Technical Service Bulletin

93 Update OBC software when replacing HV wiring harness for charging socket P31D200

93 24 47 2070110/4 March 22, 2024. Supersedes Technical Service Bulletin Group 93 number 23-17 dated July 26, 2023 for reasons listed below.

Model(s)	Year	VIN Range	Vehicle-Specific Equipment
e-tron quattro	2019	All	OBC Cluster 1
e-tron Sportback quattro	2020

Figure 1. High-voltage wiring harness for charging socket.

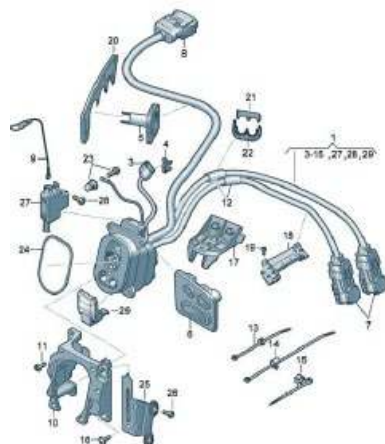
The High Voltage Wiring Harness for the charging socket UX4 or UX5 is replaced as part of any repair work (Figure 1).

The charging socket was modified in production.

From Q2 2020, only the new-generation high-voltage wiring harness for the charging socket is fitted in production vehicles.

If the high-voltage wiring harness for the charging socket is replaced as listed in Table 1.2, an SVM code will need to be performed *and a replacement test plan performed*.
